SUBJECT: PLANS AND PROPOSAL ADDENDUMS
PROJECT: STP 2023 (675)MM CONTROL: 1433-02-044
COUNTY: COMAL
LETTING: 05/04/2023
REFERENCE NO: 0419

PROPOSAL ADDENDUMS

DESCRIPTION OF ABOVE CHANGES
(INCLUDING PLANS SHEET CHANGES)

8493-01UTL10-BGE.dgn
4/19/2023

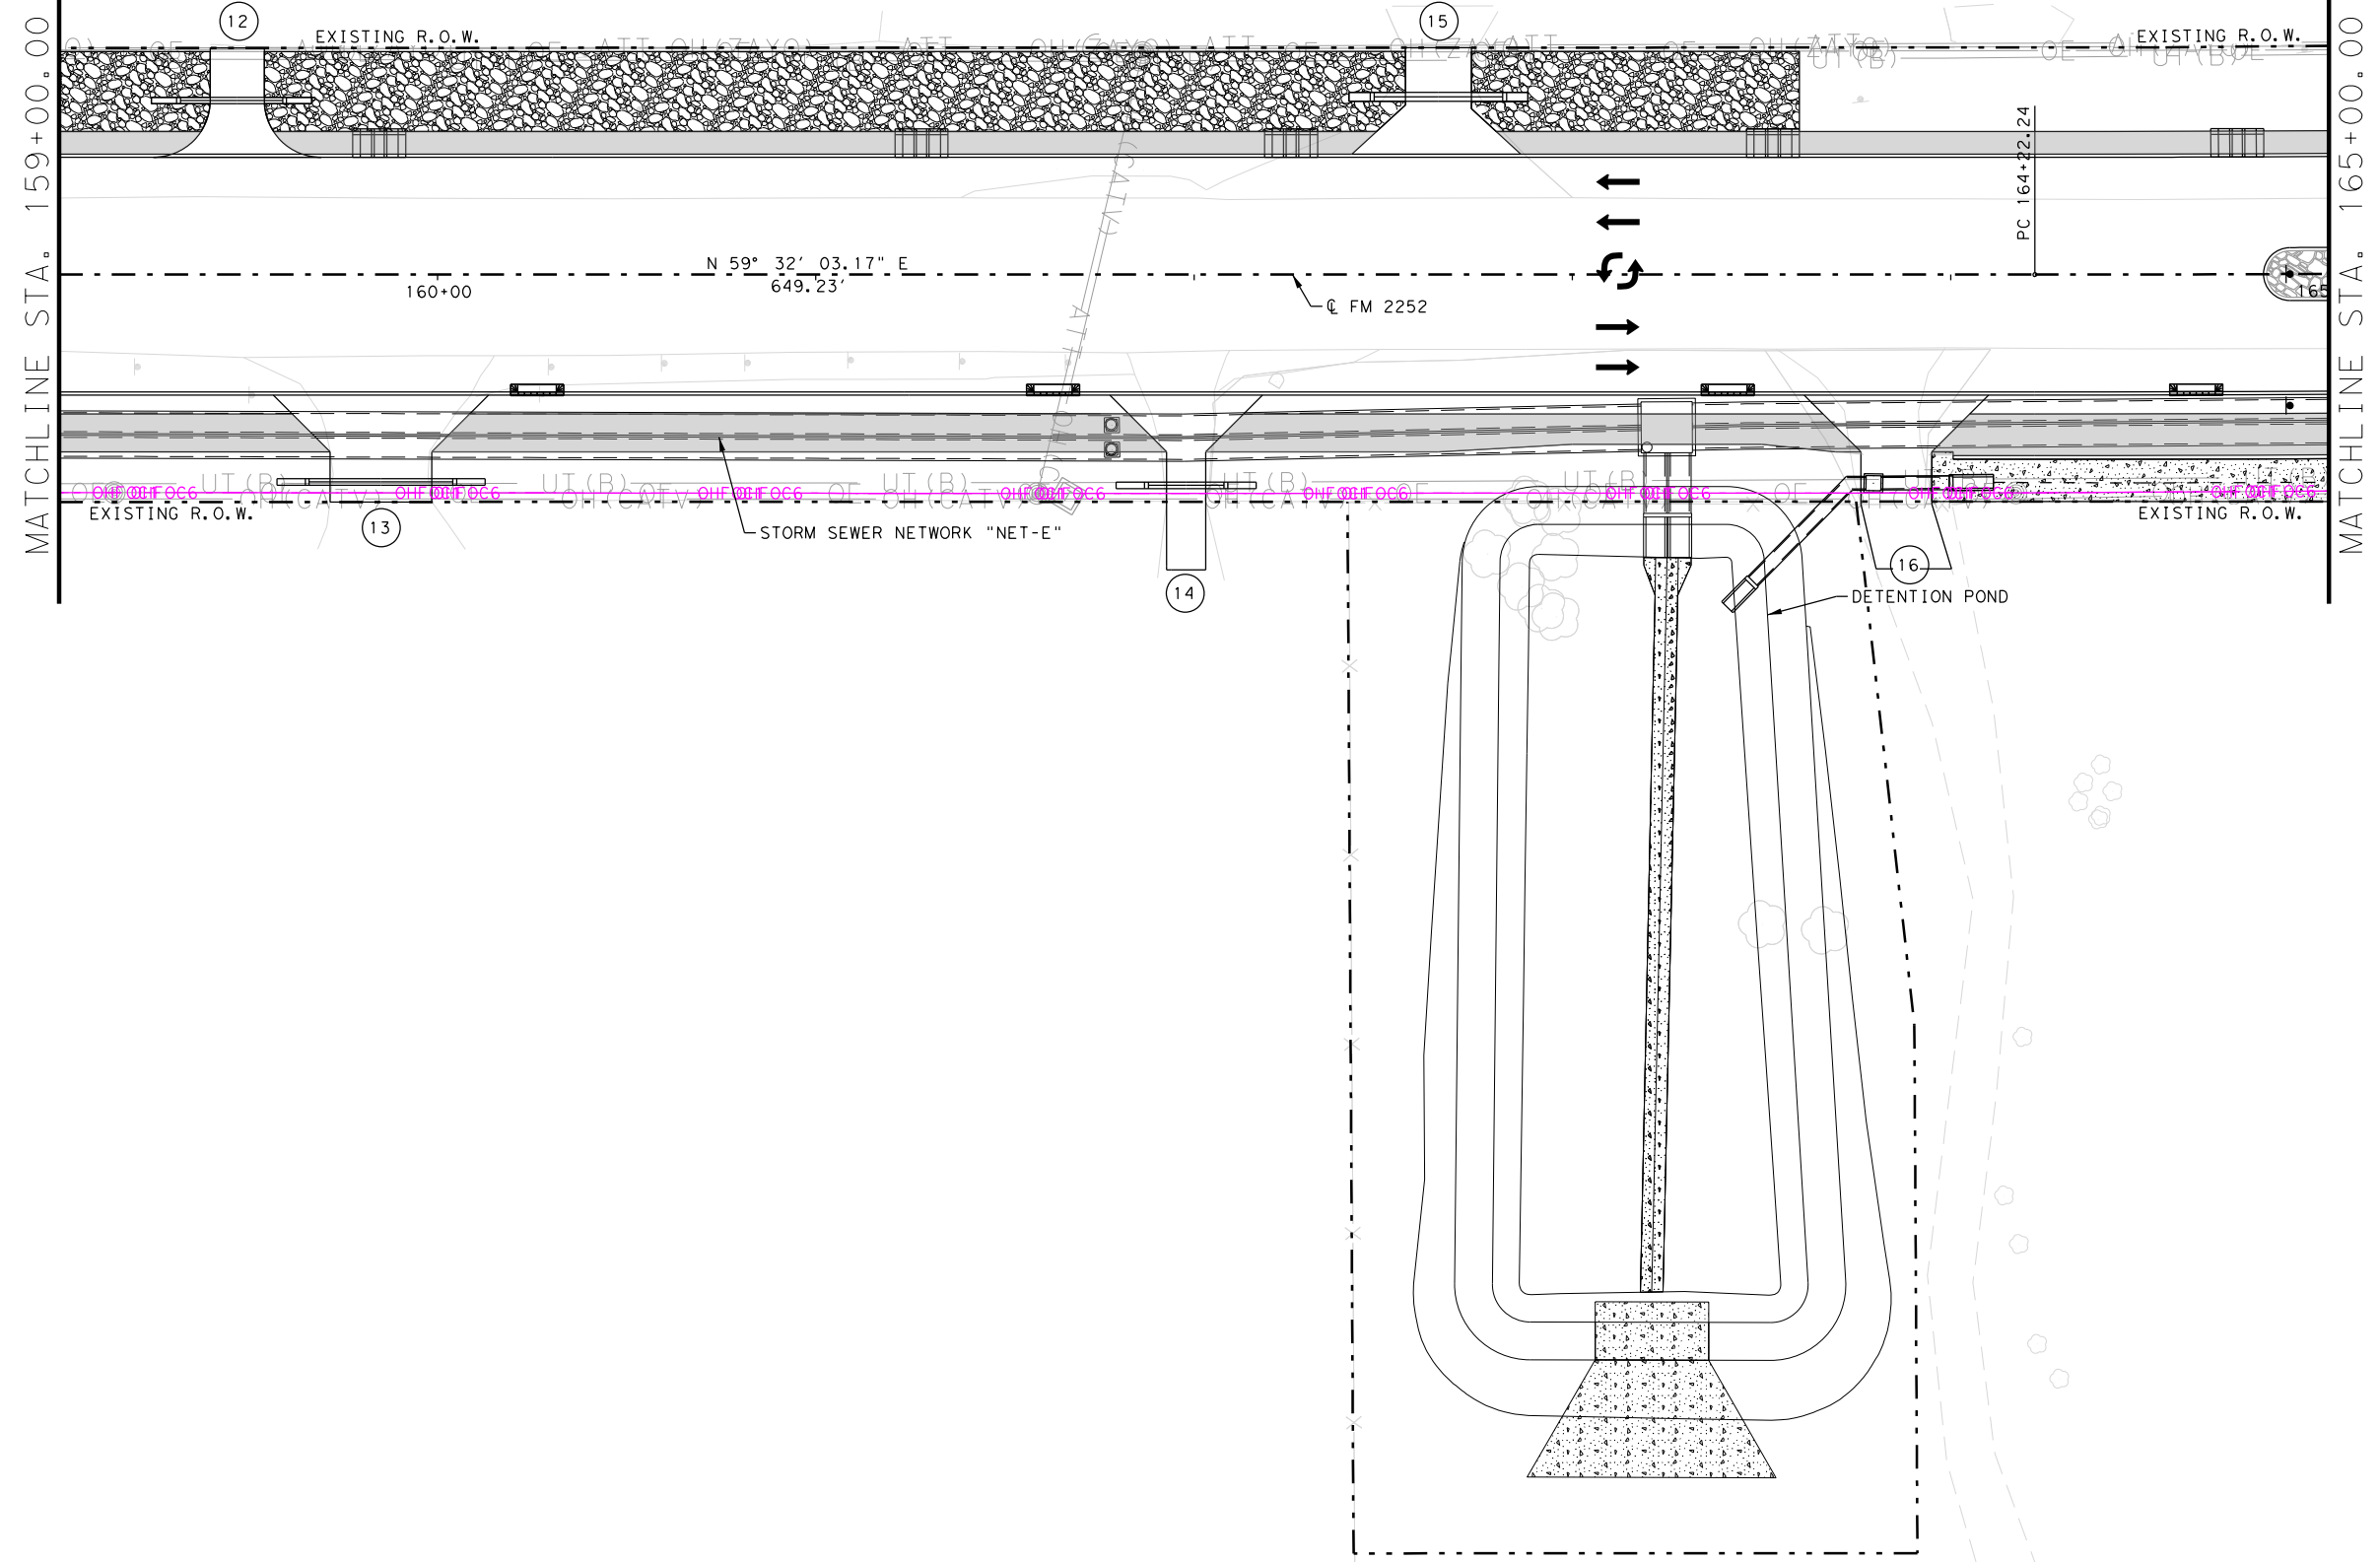
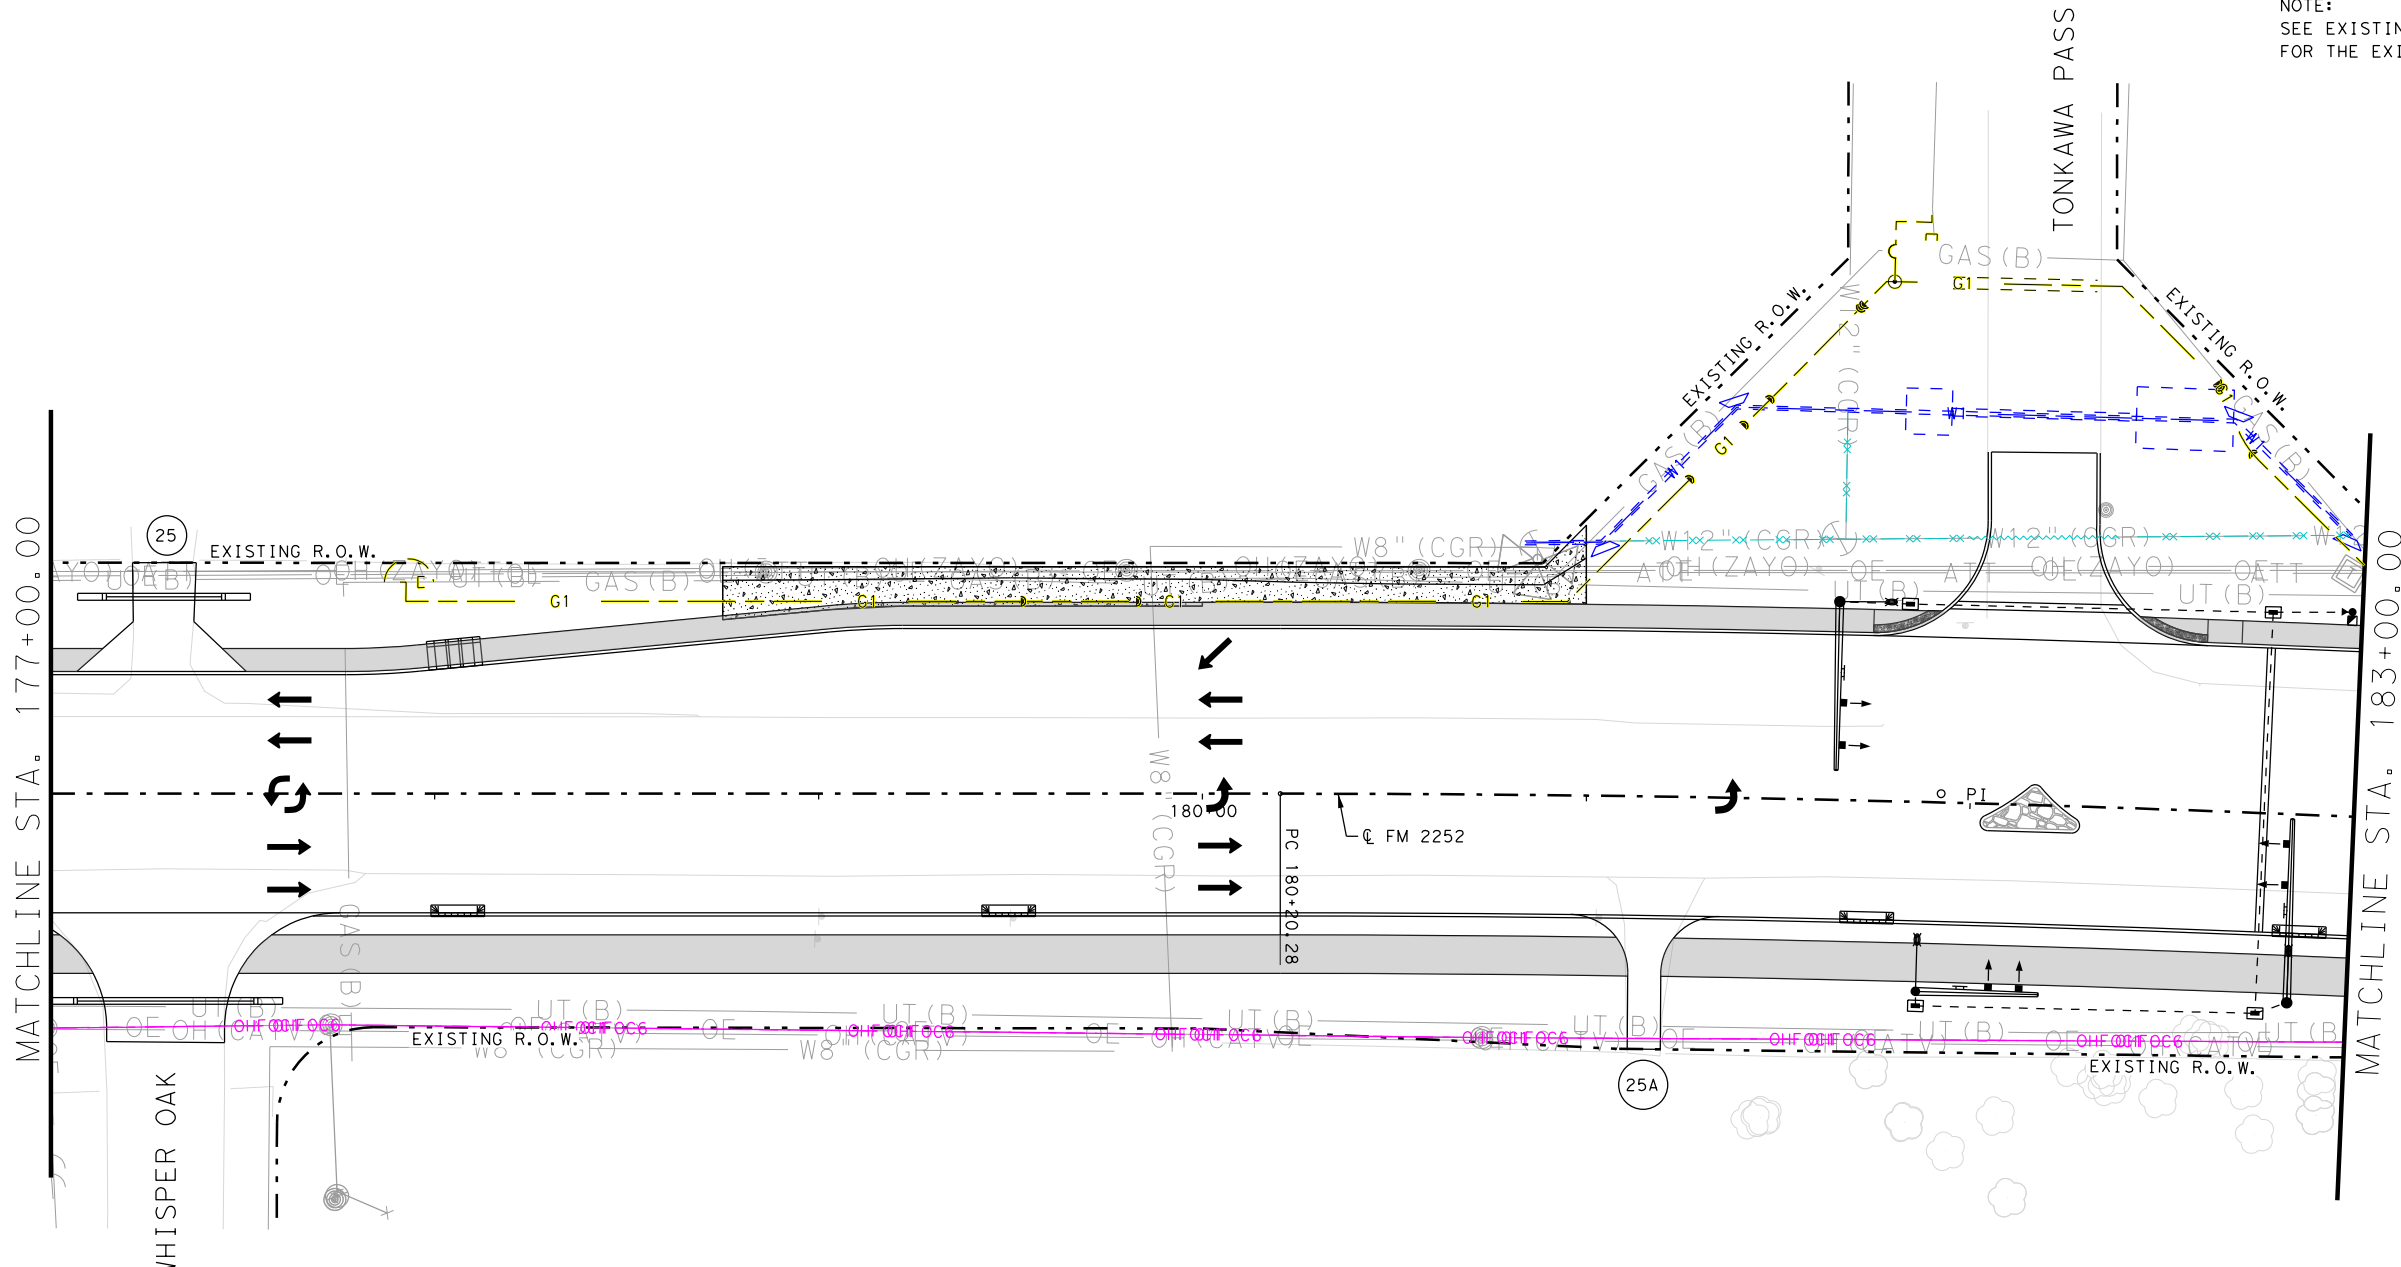
SHEETS 1330-1365: UPDATED UTILITY PLANS SHEETS LAYOUTS WITH CURRENT GAS
